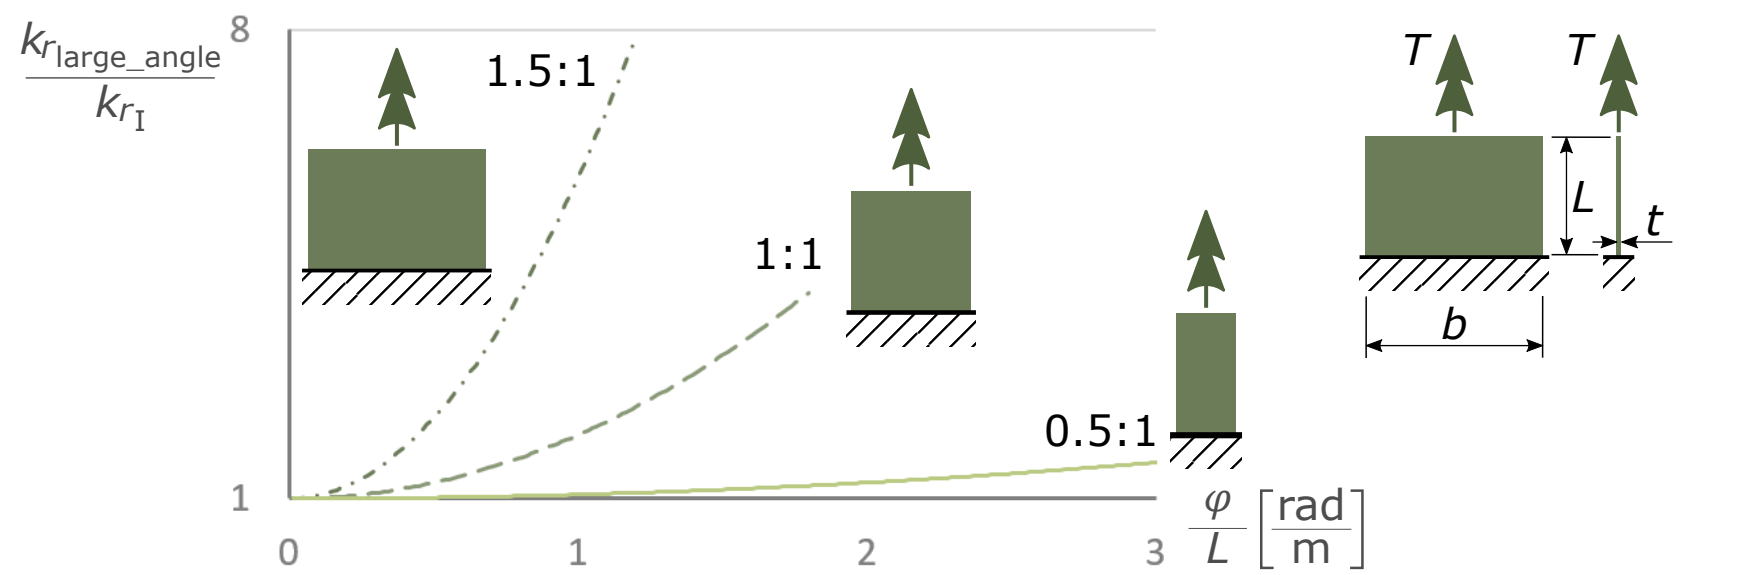
Page	**Place**	**Error**	**It should be**
12	formula 2.10	$-\frac{1}{2}\frac{\delta_c^2}{L}$	$-\frac{1}{2}\frac{\delta^2}{L}$
24	table 2.2 line 5	4 0 − 2 2 0	4 0 − 2 2 0.2
26	formula 2.22	$M = F_1 r + F_2 r$	$M = F_1 r - F_2 r$
46	formula 4.35	$k = \frac{F}{u} = \frac{3EI}{b^3 + ab^2}$	$k = \frac{F}{\delta_c} = \frac{3EI}{b^3 + ab^2}$
55	equation 5.9	$k_{\text{large\_angle}} = \frac{KG}{L} + \frac{1}{120}E\left(\frac{\varphi^2}{L^3}\right)tb^5$	$k_{r_{\text{large\_angle}}} = \frac{KG}{L} + \frac{1}{360}E\left(\frac{\varphi^2}{L^3}\right)tb^5$
56	table 5.2, line 8	$K = bt^3\left(\frac{1}{3} - 0.21\left(1 - \frac{t^4}{12b^4}\right)\right)$	$K = bt^3\left(\frac{1}{3} - 0.21\frac{t}{b}\left(1 - \frac{t^4}{12b^4}\right)\right)$
57	figure 5.10	figure of stiffening should be as in figure:
